# Historic Preservation Design Review

March 25, 2010

## HP-10-07, 210 W Calhoun St. (City)

**Request:** Design Review of a proposed replacements, upgrades, and repairs to a residential building for a proposed commercial office use.

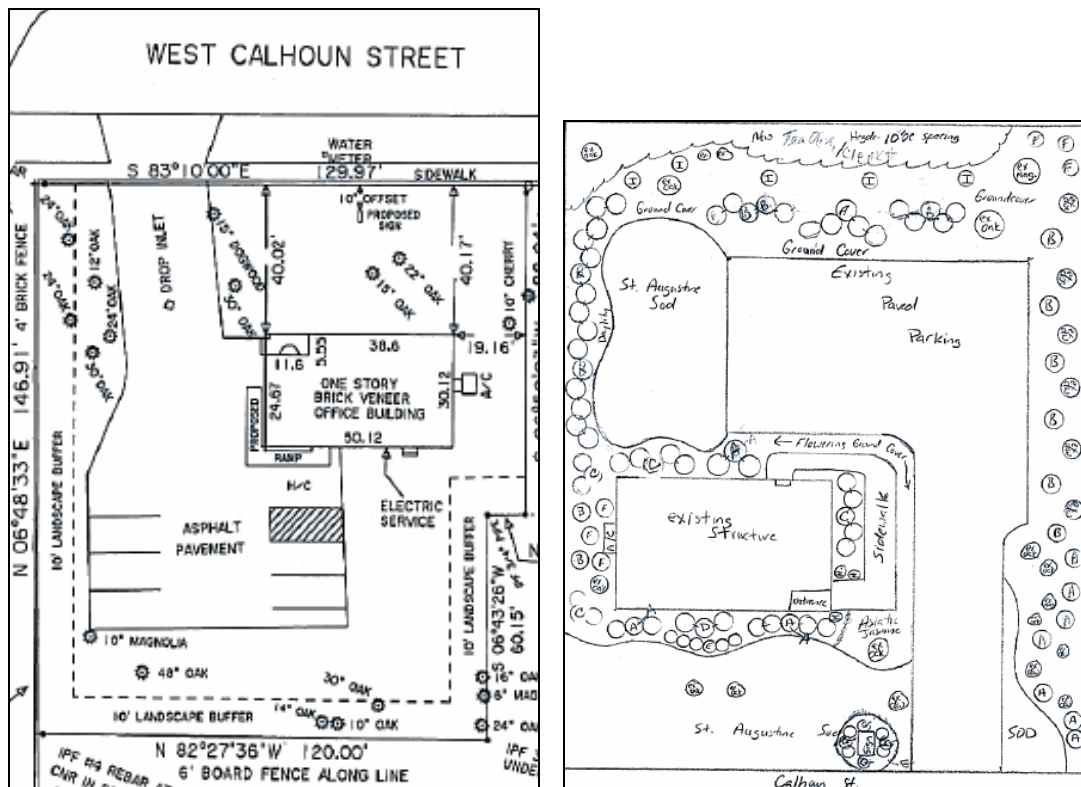
There will be a small 1 foot square professional nameplate attached to the wall beside the front door. In addition, there will be a sign structure in the front yard with brick footings to match the building, with black painted metal brackets and ironwork scrolling that has been designed to echo the front yard gate of the neighboring house to the west, shown in the photograph below.

The original wood-paneled front door is being replaced with a single-light commercial entrance door with hurricane glass. This will allow light to enter the structure and will open up the front for a more inviting appearance.

The proposed project meets most of the requirements set forth in the design review guidelines, with the exception of the front door replacement. However, the existing door is not architecturally significant in its present context, and is somewhat deteriorated. The repairs and replacement materials are compatible with historic district guidelines and will be in keeping with similar structures in the neighborhood. Therefore, staff recommends approval.
